Appendix K – Modelling Review Memorandum

To	Melbourne Water Corporation (Lauren Mittiga, Keith Boniface, Rob Considine)	
Copy to		
From	Greg Finlayson; Ryan Brotchie	Tel
Subject	Review of modelling assumptions	Job no. 3136555

GHD's internal review of the modelling conducted for the *Fishermans Bend Baseline Drainage Plan* to date, focusing on the tailwater conditions, the treatment of sea level rise and the implications for the height of the levee.

To	GHD Project Team		
Copy to	Melbourne Water		
From	Christian Taylor	Tel	+61 3 8687 8856
Subject	Review of modelling and implications for levee	Job no.	3135713

Figure 1: Change to extent and height of levee from adding Freeboard to the levee profile (grey line represents the assumed levee extent/height in the Baseline Drainage Plan, GHD 2018, and the orange line represents adding 600mm freeboard).

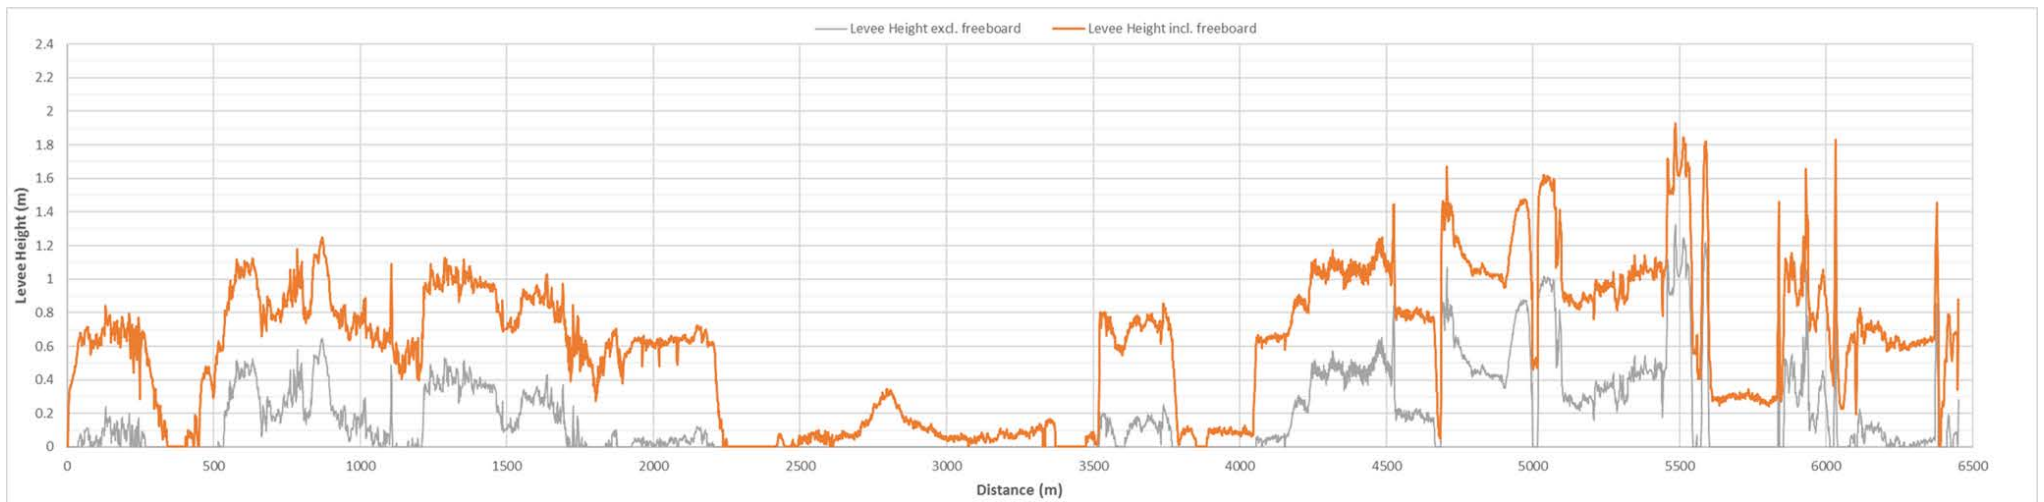
In addition to the recommendations above, which have implications for the height and extent of the levee, another specific technical finding from the review was: *The proposed levee alignment on the river bank will require increased freeboard due to vessel wake and local increases in water level where flood flows meet obstructions such as bridge abutments.*

The Baseline Drainage Plan doesn't currently allow for freeboard. The DELWP Levee Management Guidelines provide a starting rule of 600mm freeboard for public urban levees, but they do note the freeboard may be increased/decreased depending on conditions & knowledge. It appears that it is MWC's responsibility to set this requirement. Figure 01 over page shows the difference in extent/height of the levee with and without the freeboard allowance.

That 600mm freeboard be allowed for the levee at Fishermans unless Melbourne Water provide clear guidance as to why freeboard should be reduced.

Figure 3 Modelled flood profiles for the Lower Yarra from *Yarra River Flood Mapping project* (GHD 2018, Draft)

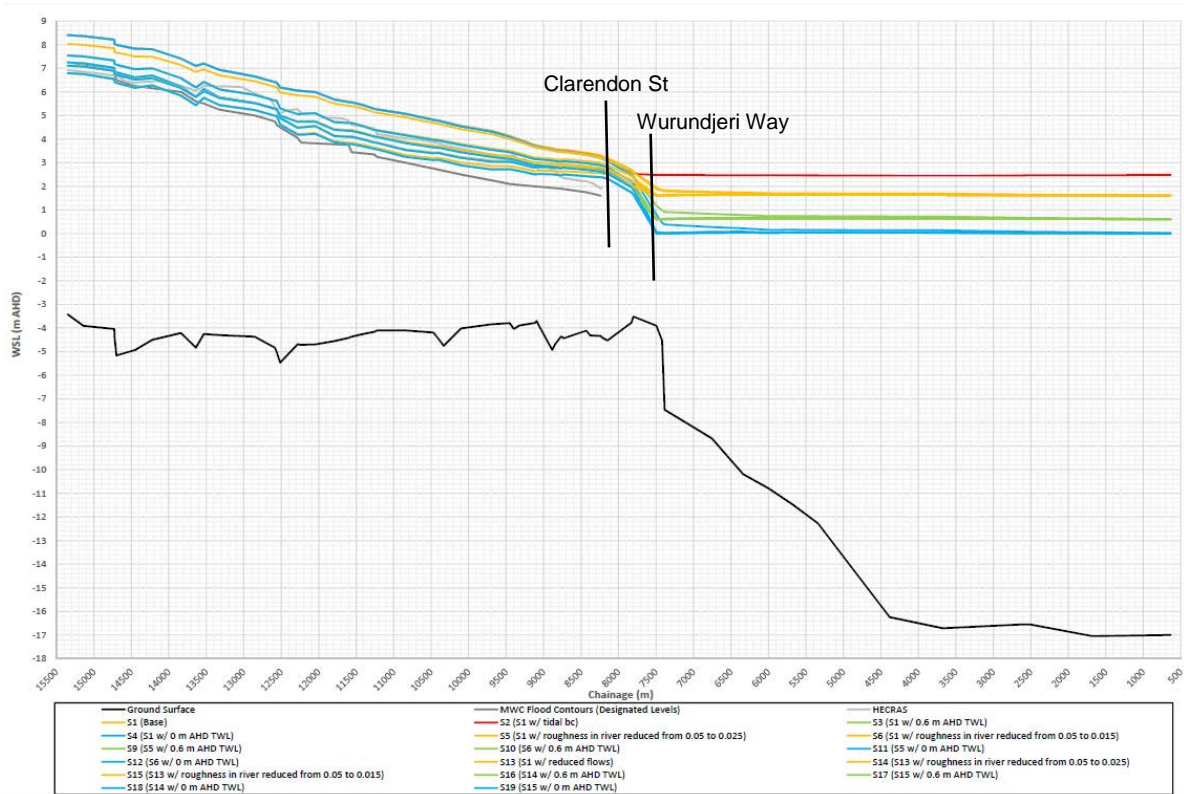
However, upstream of Wurundjeri Way the river levels appear to be flow-dominated during flood events and are higher than the Bay level. *It is important to note the current Melbourne Water designated flood level is lower than 2.25m AHD, and so in modelling to date the 2.25m AHD tailwater condition has been assumed to be appropriate. However GHD is aware of a flood study underway for the Lower Yarra that is underway, for which preliminary results indicate that flood flows in the lower Yarra may be up to 3.3m AHD.*

Yarra River 1% AEP flood profiles given in *Yarra River Flood Mapping project – Modelling Assumptions & Implications* (Memo from GHD to Melbourne Water dated 29 March 2018) clearly show that for the river below Wurundjeri Way are principally determined by the bay level and river flow has a very minor influence (refer Figure 3). However, upstream of Wurundjeri Way the river levels are flow-dominated during flood events and are higher than the Bay level (refer Figure 3). As flood flows are not included in the current modelling it will be underpredicting flood levels in the eastern-most part of the site which floods from the Yarra upstream of Wurundjeri Way.

- Due to the effect of flooding from the Yarra during catchment flood events, the levee will need to be higher in the area upstream of Wurundjeri Way and may need to extend further upstream than the current model boundary at Clarendon St to protect the eastern most precinct.
- The proposed levee alignment on the river bank will require increased freeboard due to vessel wake and local increases in water level where flood flows meet obstructions such as bridge abutments.
